MFN 06-274

Subject: Response to RAI Letter Number 20 Related to ESBWR Design Certification Application – Seismic Design – RAI Numbers 3.7-16, 3.7-24, 3.7-27, 3.7-30, 3.7-32, 3.7-33, 3.7-35, 3.7-37, 3.7-38, 3.7-39, 3.7-50, 3.7-54 and 3.7-57

**Response to NRC RAI Letter No. 20 Related to ESBWR Design
Certification Application**

Shimizu Engineering Report																	
Project	General Electric Company ESBWR Project		Shimizu Document No.	SER-ESB-033													
Title	Parametric Evaluation of Effects on SSI Response		Rev.	0													
			Issued Date	8/14/06													
			Revised Date														
<p>NOTE:</p> <p>This document provides additional SSI analyses performed and results obtained for the Reactor/Fuel Building Complex (RBFB) the Control Building (CB) to address the following issues identified in RAIs.</p>

Figure 3.7-37 (1) Frequency-Dependent vs. Frequency-Independent Soil Spring for RB/FB at Soft Site

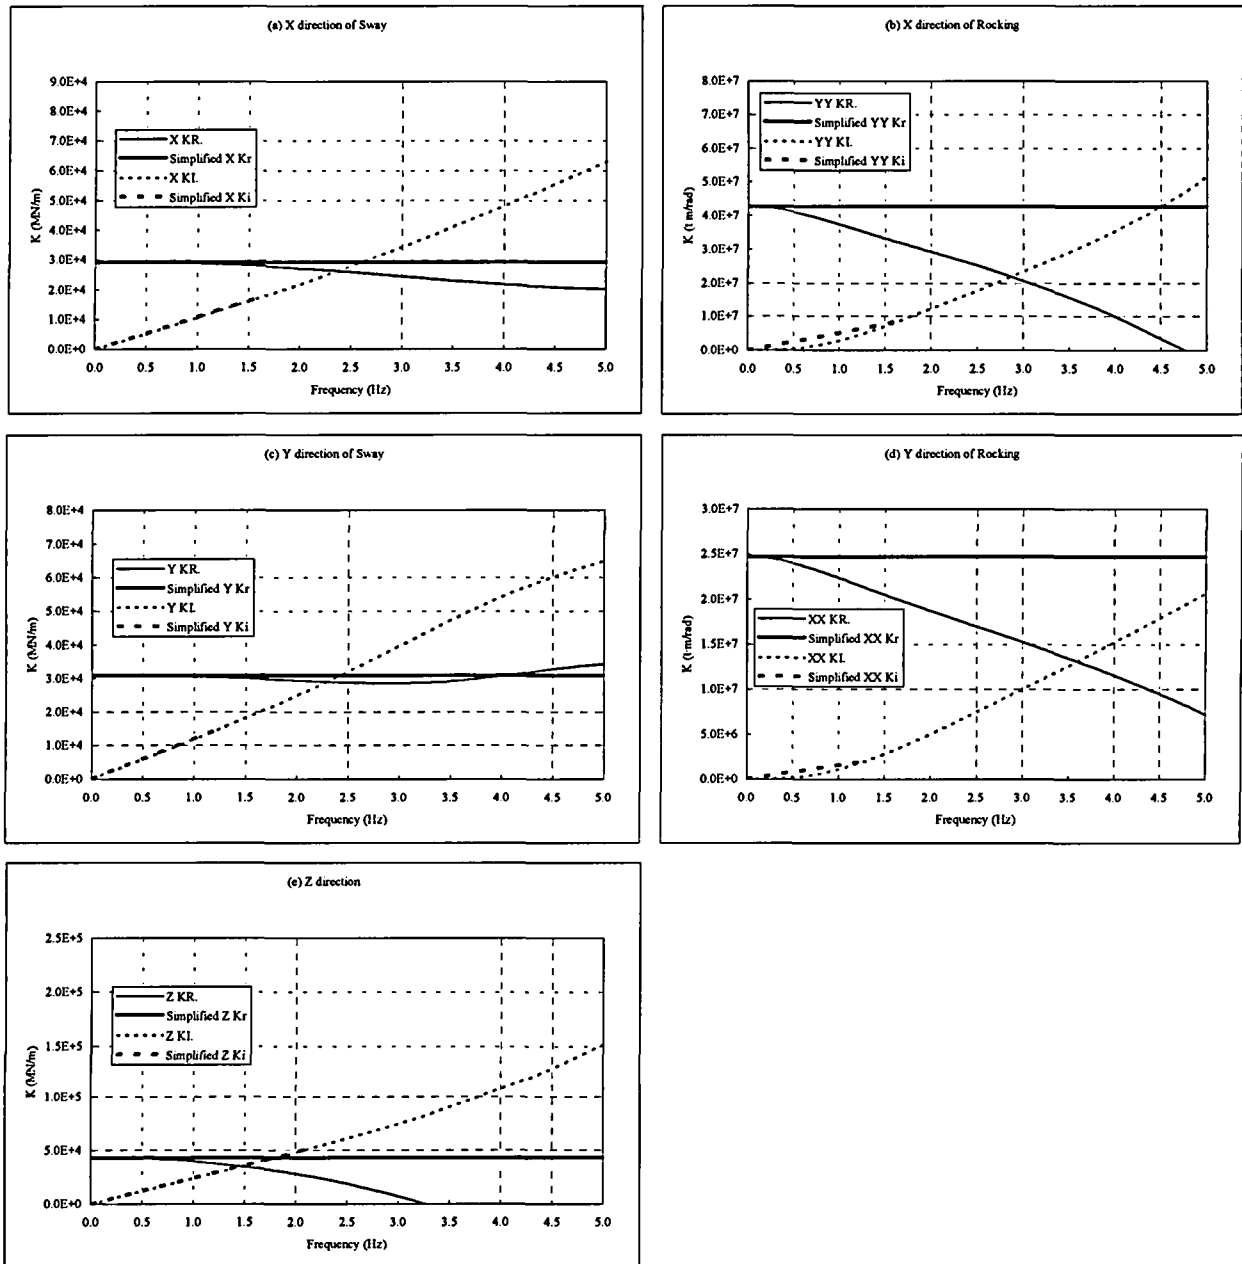
In the third paragraph of DCD Appendix 3A, Section 3A.5, the applicant discussed how to use the frequency-independent soil-spring K_c and damping coefficient C_c to represent the soil foundation in the SSI analysis of the RB/FB and CB. DCD Tables 3A.5-1 and 3A.2 provide tabulated numerical values of K_c and C_c for the RB/FB and CB. However, the applicant did not describe in the DCD how the frequency-dependent soil-springs (real and imaginary parts of the soil stiffness) were calculated, and how these frequency-dependent soil-springs were converted to frequency-independent soil-springs and damping ratios. The staff requests the applicant provide a detailed description in the DCD.

The detailed description for the calculation of the frequency-dependent soil-springs (real and imaginary parts of the soil impedance) was provided in the response to RAI 3.7-49, in which the procedure used to convert these frequency-dependent soil impedance to frequency-independent soil stiffness and damping ratio was also described. An illustrative example for comparison of the calculated frequency-dependent impedance with the equivalent frequency-independent soil stiffness and damping is shown in Figure 3.7-37 (1) for the soft site.

DCD Section 3A.5 will be revised in the next update as noted in the attached mark-up to provide a detailed description.
